9 SUB-000551-2018

TAYLOR'S EAST RIDGE SUBDIVISION

DETAIL SITE PLAN

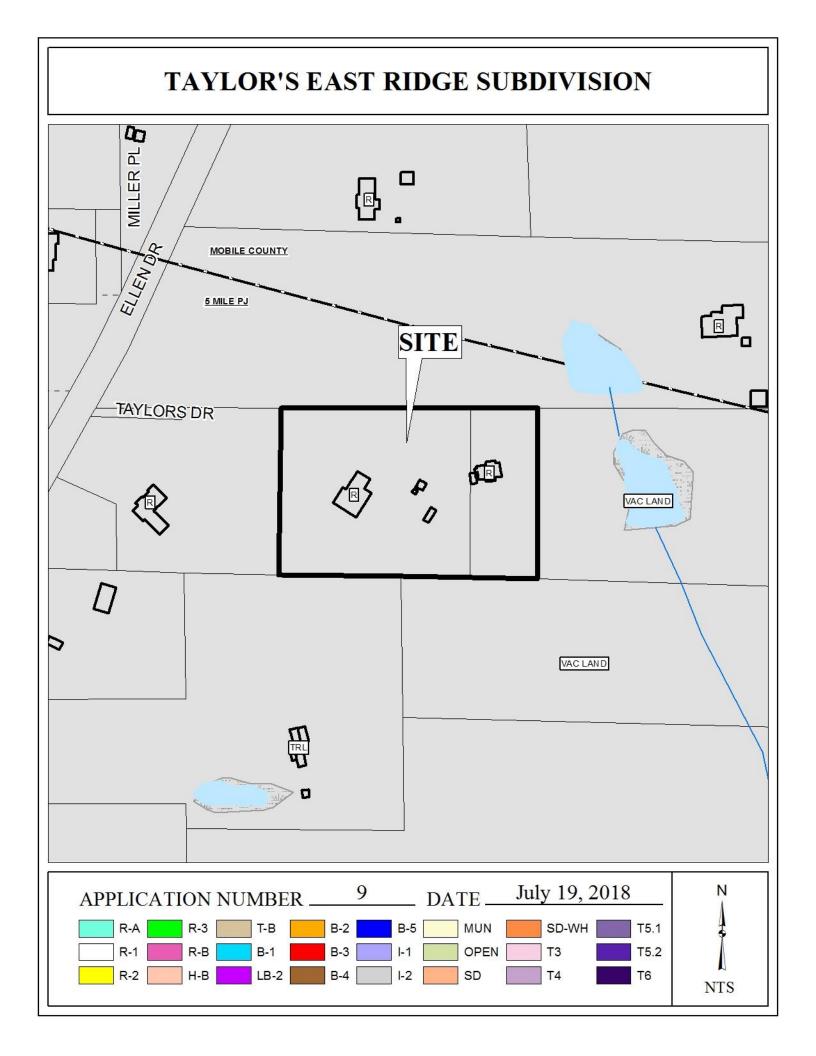
The proposed Lots 1 and 2 front Taylor's Drive, a private road with a 50' right-of-way width. If approved, the 50' right-of-way to Taylor's Drive should be retained on the Final Plat.

The preliminary plat illustrates a 25' minimum building setback line along Taylor's Drive for both lots. If approved, the 25' minimum building setback lines for Lots 1 and 2 should be retained on the Final Plat.

In accordance with Section V.D.2. of the Subdivision Regulations, the proposed lots each exceed the 15,000 square foot minimum lot size requirement for lots served by public water and individual septic systems. The lot size information for each lot is depicted in both square feet and in acres on the preliminary plat and should be retained on the Final Plat, if approved.

As a means of access management, a note should be placed on the Final Plat, if approved, stating that Lots 1 and 2 are limited to one curb cut each, with the size, design and location of the curb cut to be approved by Mobile County Engineering and conform to AASHTO standards.

- 1) Retention of the 50' right-of-way width to Taylor's Drive (private street);
- 2) Retention of 25' minimum building setback line along Taylor's Drive for Lots 1 and 2;

- 3) Retention of the lot size information in both square and in acres on the Final Plat;
- 4) Placement of a note on the Final Plat stating that Lot 1 and Lot 2 are limited to one curb cut each, with the size, design and location of the curb-cut to be approved by Mobile County Engineering and conform to AASHTO standards;
